## Introduction

This document contains suggestions for revising the current “final draft” of the Nokomis East Station Area Plan, as prepared by Hay Dobbs and the City of Minneapolis, dated October 1, 2006.

*November 15, 2006*

2.9.3 *Potential Building Expressions* – p. 2-29; 4th ¶

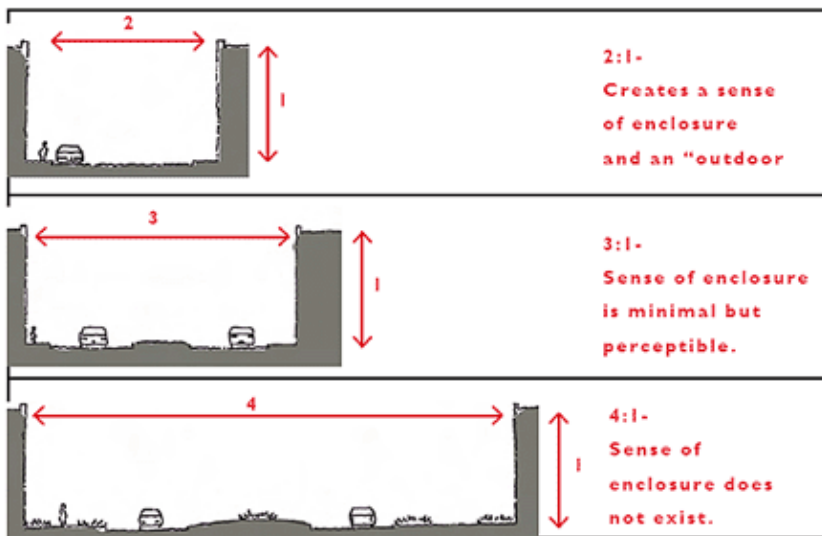
NENA agrees with the 2:1 “Outdoor Room” spatial formula. Assuming an approximate 90 foot distance between building frontages under the plan (18’ + 13’ + 20’ + 13’ + 18’), a 45 foot building height is appropriate. Unfortunately the illustration does not represent the three ratios in an easy-to-understand manner and has led to confusion among readers. Because the Minnehaha cross-section is a relatively fixed width, it would be better to redraw the three sections with a constant width (perhaps as in the 3:1), but with varying vertical sections to better illustrate the ratios. The illustration either needs changing or dropped from the Plan’s text.
